Re: Draft Scarborough Park Masterplan

Thank you for the opportunity to comment on the exciting draft masterplan for Scarborough Park (the 'Masterplan').

Figure 1: Typical cross section of the separated walking and cycling paths to be constructed for the M6 ATC, showing a 1m median and shoulders (Source: TfNSW)

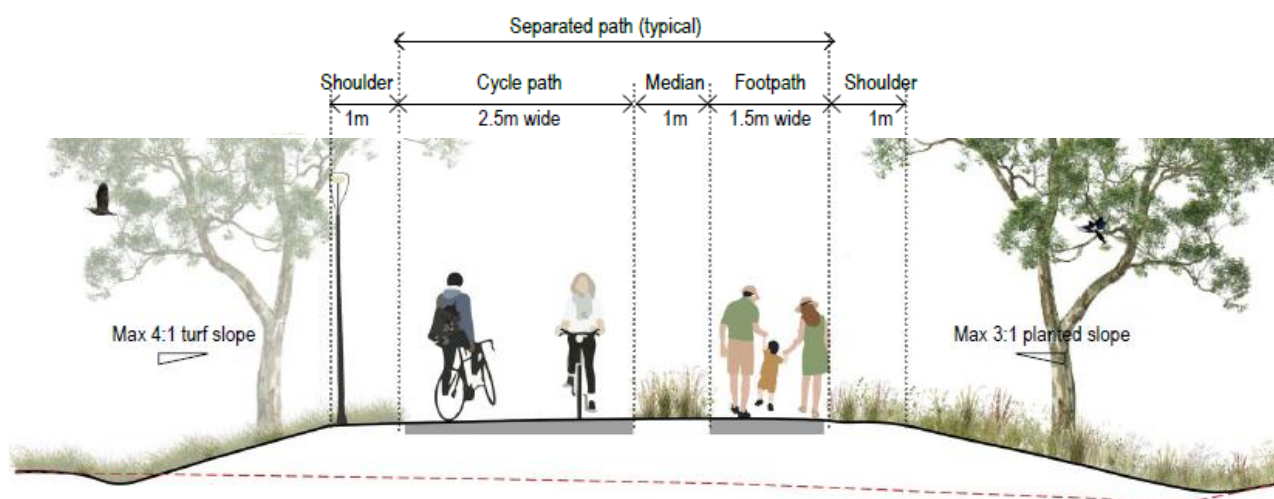
Bicycle NSW strongly recommends separation of path users. This would continue the separated paths being constructed for the M6 ATC (Figure 1). Path usage will grow with the new connections north. Bayside is already struggling with conflict on the heavily-used shared paths along the foreshore. The Scarborough Park Masterplan offers an opportunity to future-proof the infrastructure - and avoid expensive upgrades in the future.
